FILE NUMBER: Z223-272(JA) **DATE FILED:** May 31, 2023

LOCATION: Property bounded by Millmar Drive, Shiloh Road, Healey Drive, and Casa Oaks Drive

REQUEST: An application for a Specific Use Permit for a public school other than an open-enrollment charter school on property zoned an R-7.5(A) Single Family District.

SUMMARY: The applicant proposes to construct a new public elementary school to replace an existing public school. *[Edwin J. Kiest Elementary School]*

CPC-Recommended SUP Site Plan

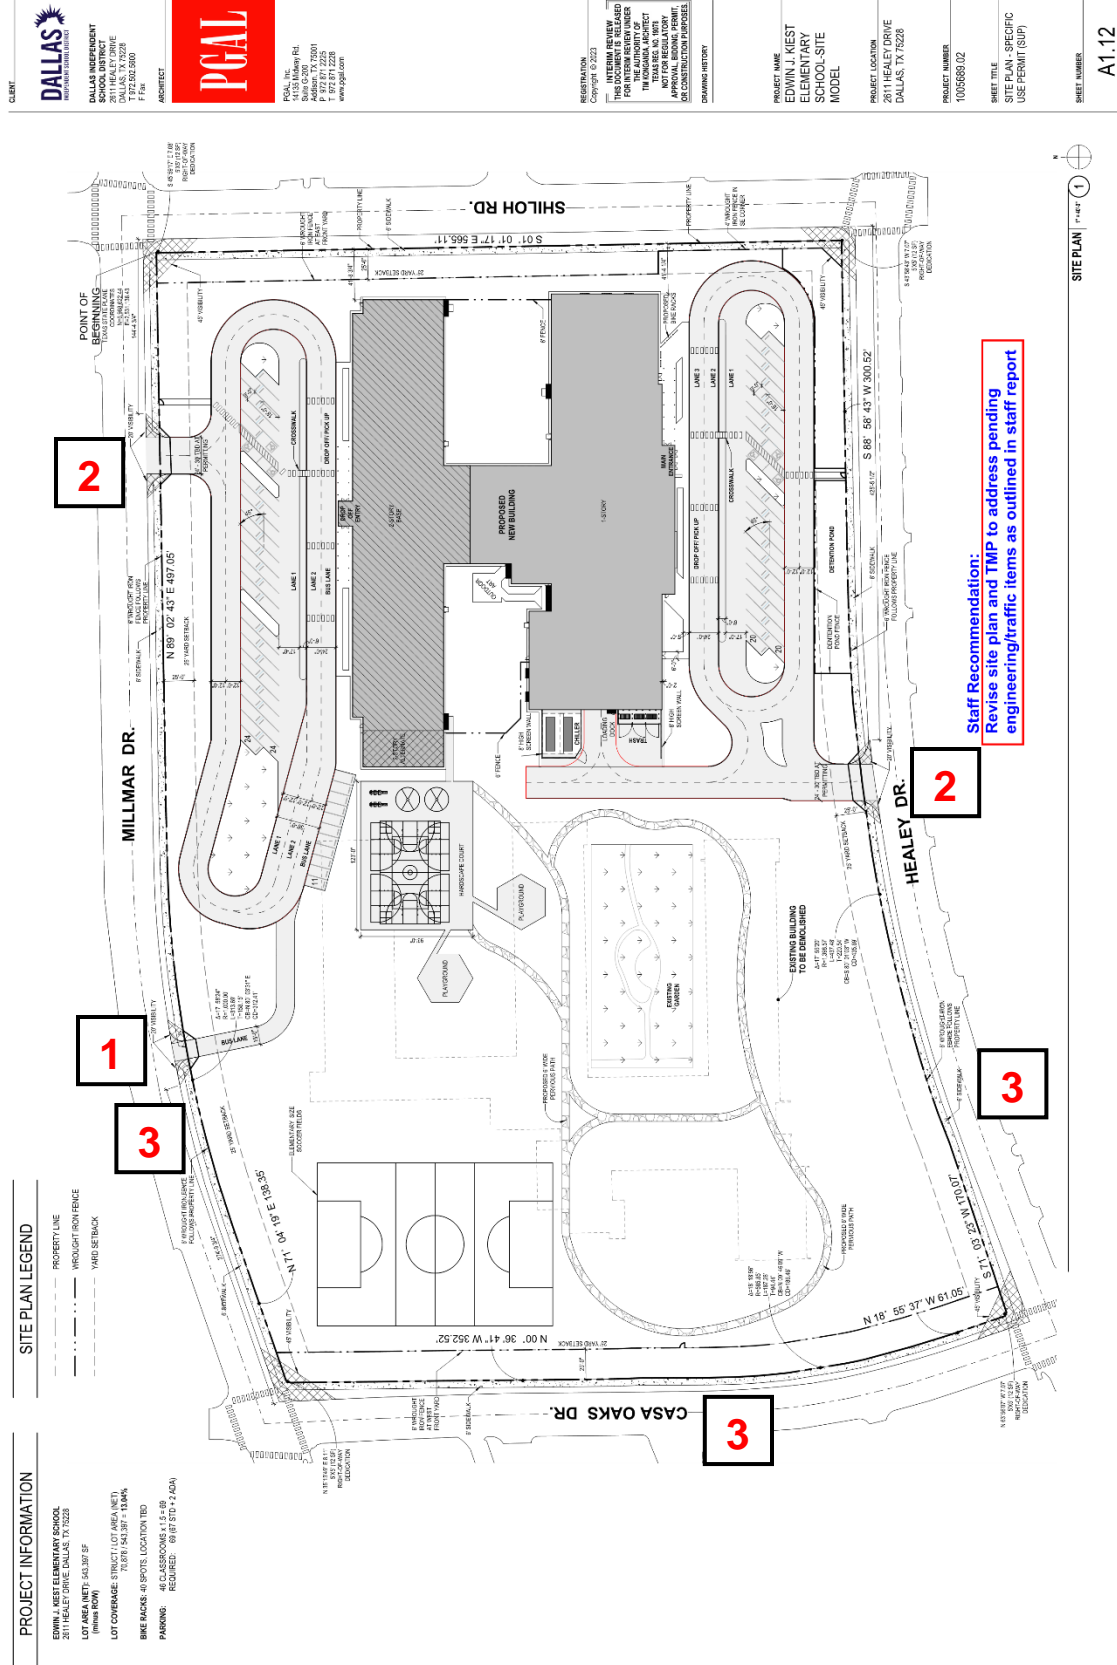
The Transportation Development Services Division of the Transportation Department has reviewed the current zoning request and notes the following pending items (*boxed numbers correspond to numbered locations on CPC-recommended site plan shown later in this report*):

1

Bus driveway remains unresolved. Staff recommends removal of driveway.

Staff Notes: Staff recommends removal of this additional driveway because it creates an additional conflict point between pedestrians and vehicles. While staff understands that the applicant is proposing the separate bus driveway in an effort to keep buses separate from parent vehicles at peak drop off and pick up times, staff recommendation remains that the separate bus driveway be removed,

2

Staff recommends a maximum width of 24 feet at vehicle access points (city standard for this use at this location).

Staff Notes: The CPC recommendation regarding this item was to include a note at the easternmost drive approach on Millmar Drive and at the drive approach on Healey Drive indicating a width between 24ft-30ft to allow the discussion to be addressed at permitting. While staff accepts this as a compromise for the zoning application phase of the project, staff continues to recommend a maximum driveway width of 24 feet to ensure that vehicles must reduce speed as much as possible at these conflict points between vehicles and pedestrians/bicyclists.

3

CPC-recommended site plan still does not provide sufficient access for pedestrians and bicyclists on the western portion of the property.

The CPC-recommended site plan directs pedestrians and bicyclists to singular access points on the eastern portion of Millmar Drive and Healey Drive, making it virtually impossible for pedestrians/bicyclists to access the property and school building without crossing vehicular access points to the property.

Staff recommends pedestrian/bicycle access, including paved pathways, between building entries and all public rights-of-way. For this location, one additional access point with paved pathway on the western portion of Millmar Drive, one additional access point with paved pathway on Casa Oaks Drive, and one additional access point with paved pathway on the western portion of Healey Drive will provide sufficient access for pedestrians and bicyclists without requiring crossing a vehicular access point.

- 1. Revise the site plan and traffic management plan to address pending items outlined in the "Traffic" section (above) of this report to include the following:*
 - a. remove bus driveway;*
 - b. revise curb cuts for vehicular access to comply with city standard for the use/location [24-foot maximum driveway width; 15-foot maximum radii at approach]; and*
 - c. add at least one additional access point for pedestrians and bicyclists at the western end of Millmar Drive, Casa Oaks Drive, and the western end of Healey Drive, including paved pathways between the building and these access points.*
- 2. Revise condition language to follow staff recommendation/applicant's request.*

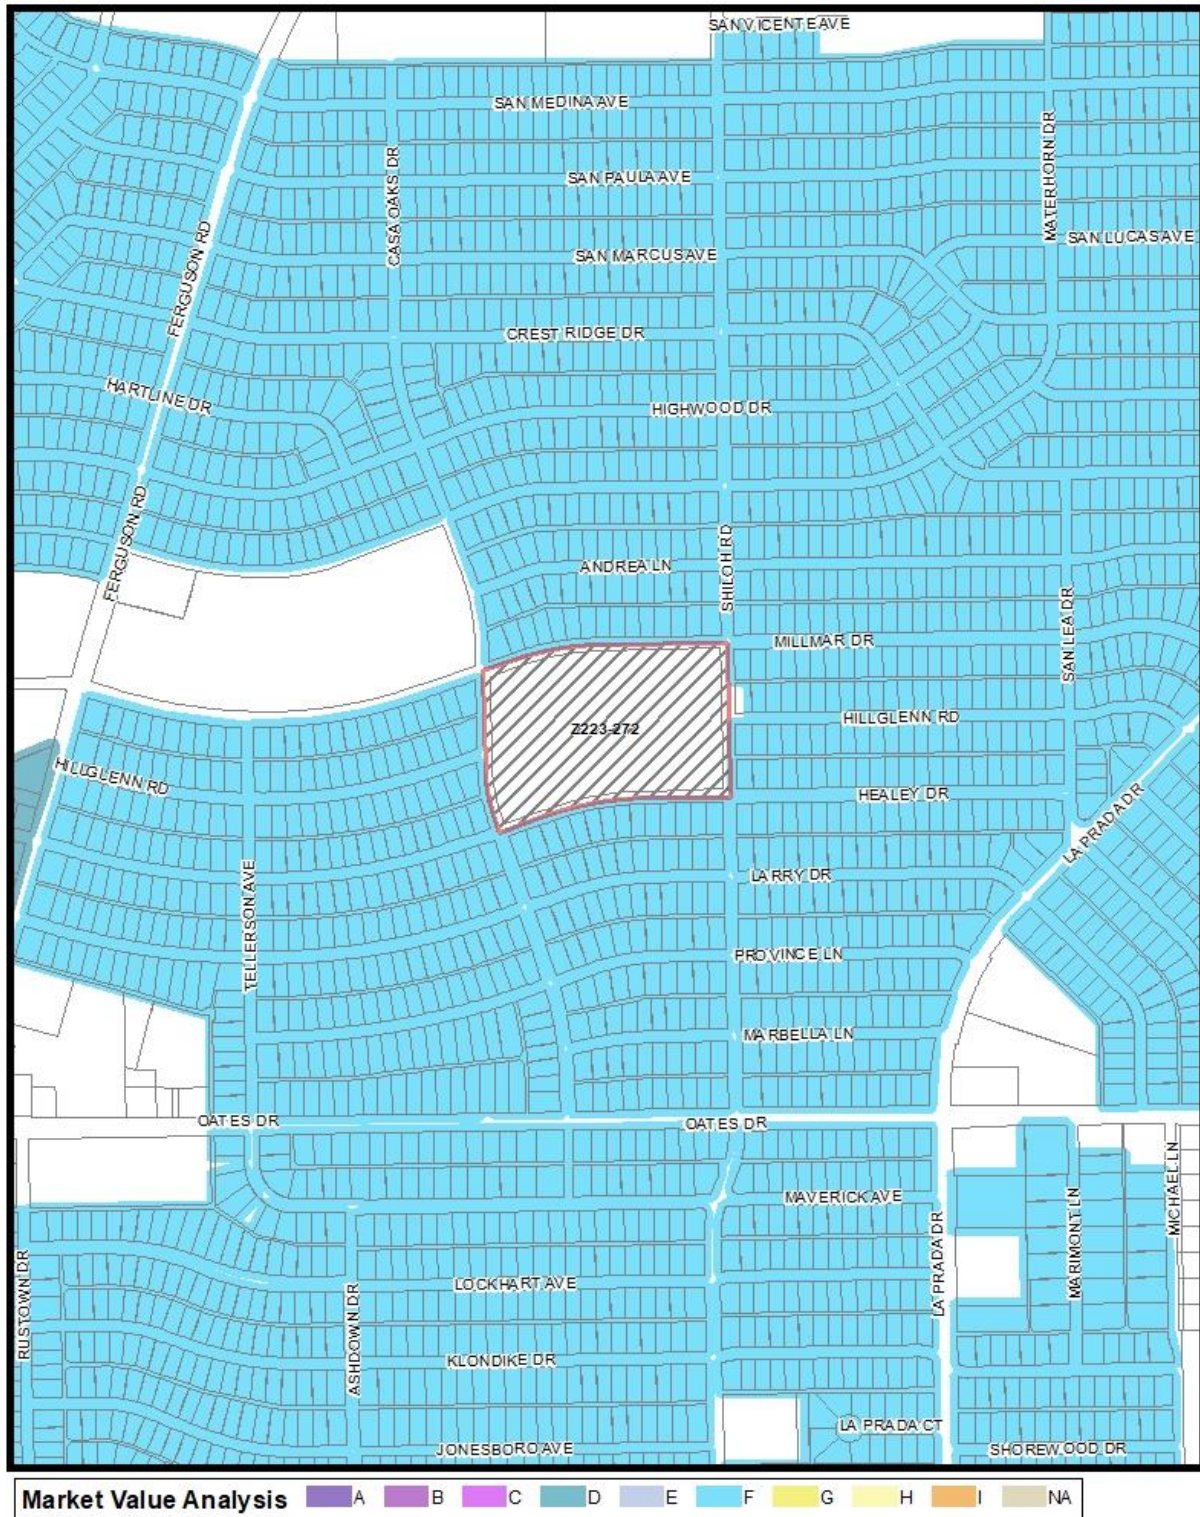
- ADDED COMMENT: the TMP Exhibit 1 notes pedestrian access point: to be indicated on revised exhibit on property zoned an R-7.5(A) Single Family District bounded by Millmar Drive, Shiloh Road, Healey Drive, and Casa Oaks Drive.

Revise site plan and TMP to address pending engineering/traffic items as outlined in staff report
